SUNDRY NOTICES AND REPORTS ON WELLS
Do not use this form for proposals to drill or to re-enter an abandoned well. Use Form 3160-3 (APD) for such proposals.

8. Well Name and No. JAN FEDERAL #1

SCHEMATIC PRIOR TO PLUG AND ABANDON
JALAPENO CORPORATION
JAN FEDERAL NO. 1
CHAVES COUNTY, NEW MEXICO
API NO. 30-005-64154

SCHEMATIC AFTER PLUG AND ABANDON
JALAPENO CORPORATION
JAN FEDERAL NO. 1
CHAVES COUNTY, NEW MEXICO
API NO. 30-005-64154

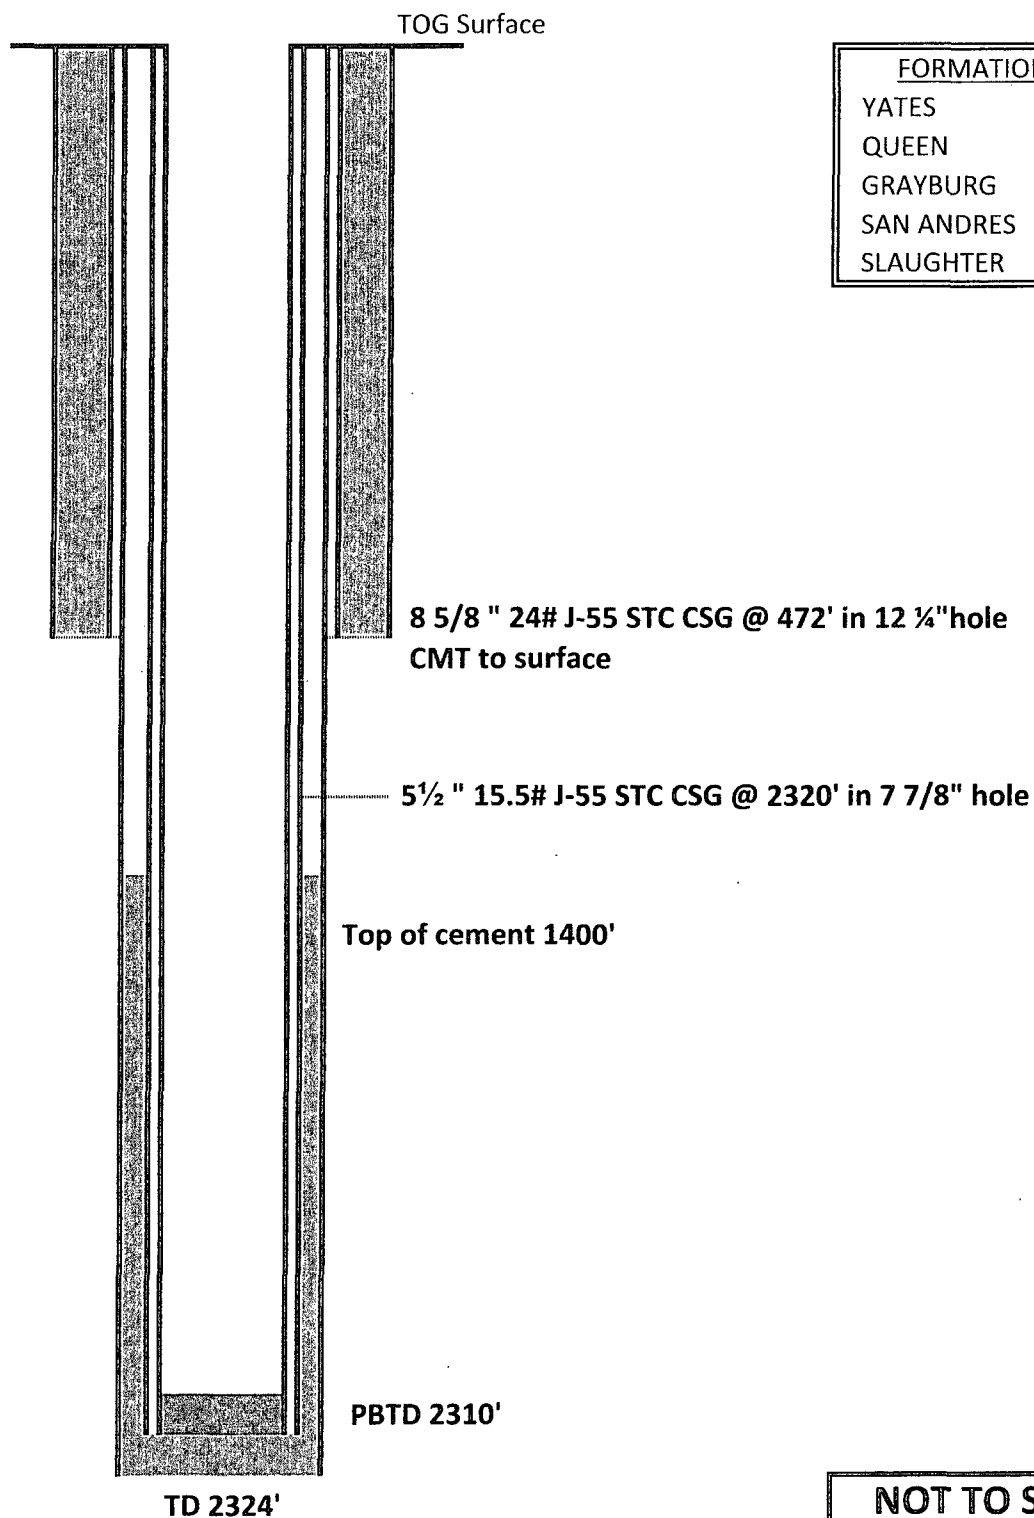
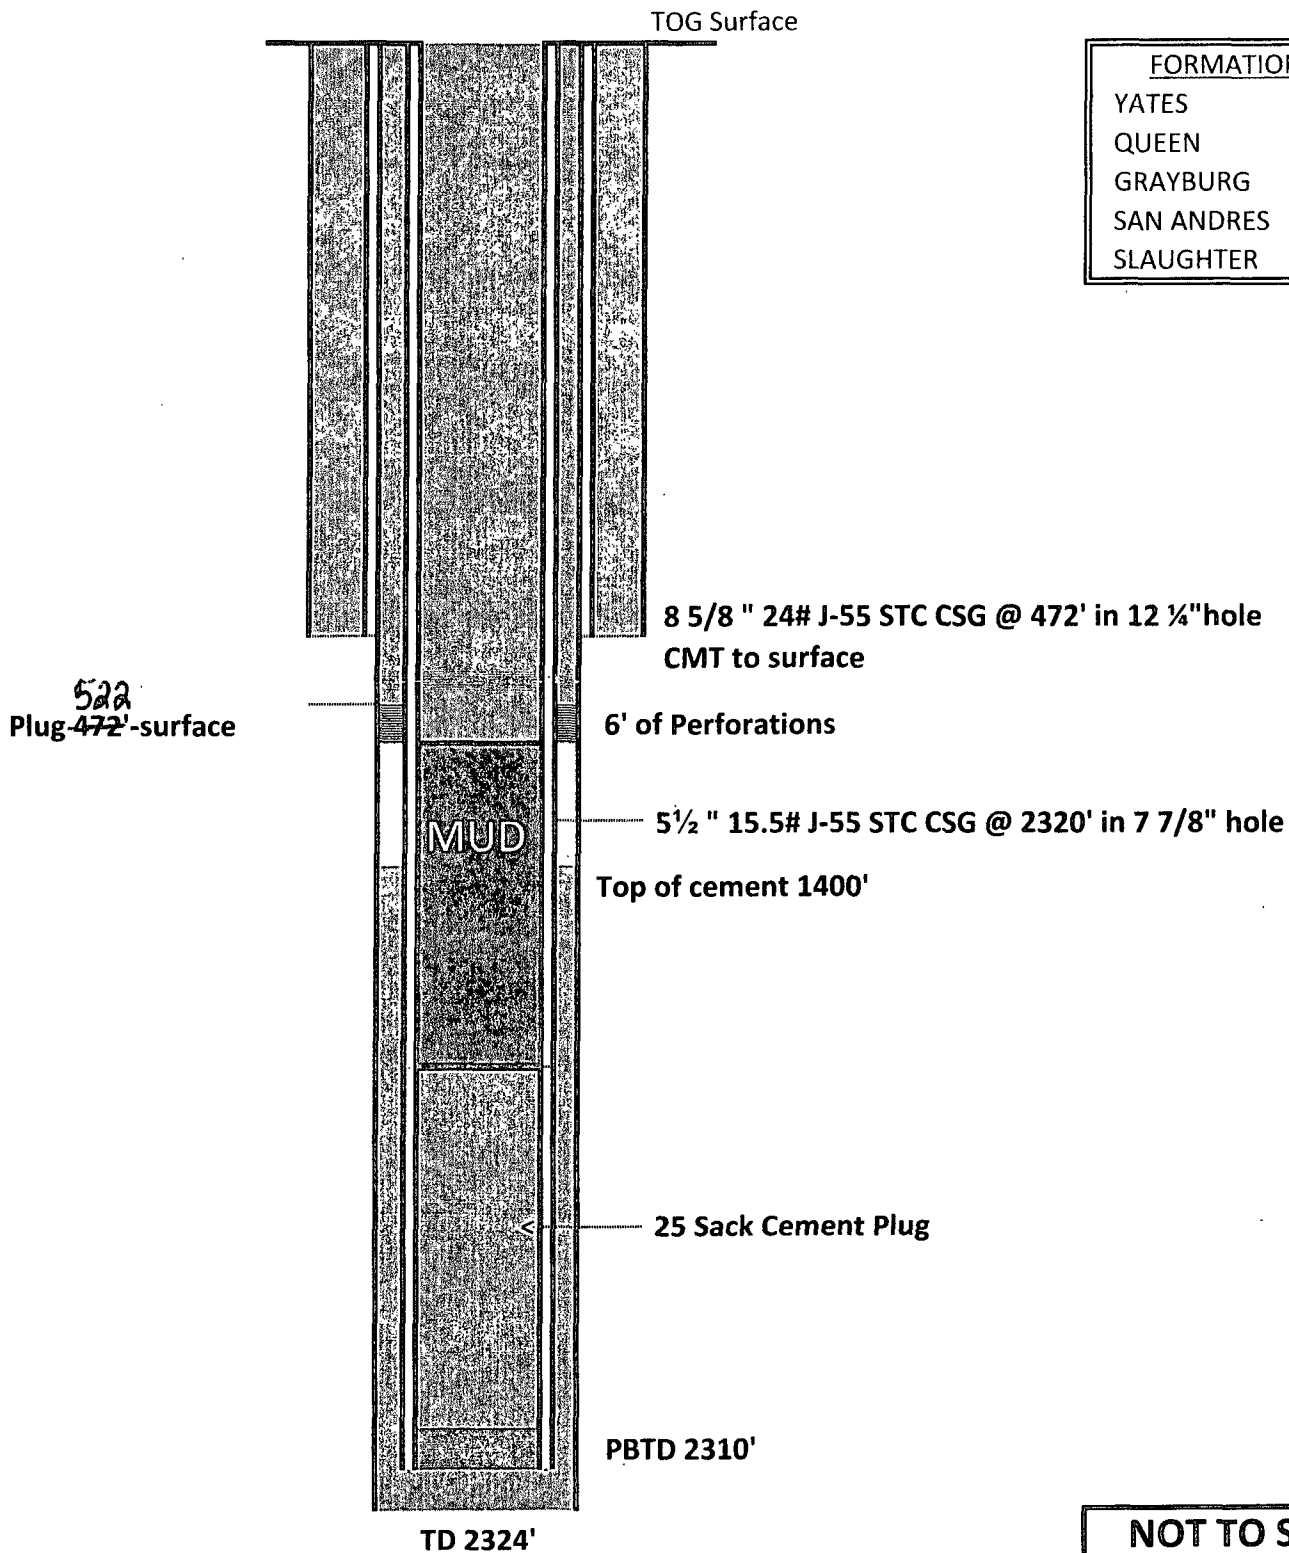
2. Wait for cement to dry and tag. **20' or Above 2210' - Witness**

4. Perforate 50 feet below Surface Shoe and cement hole to surface. **Circulate From 522' To Surface**
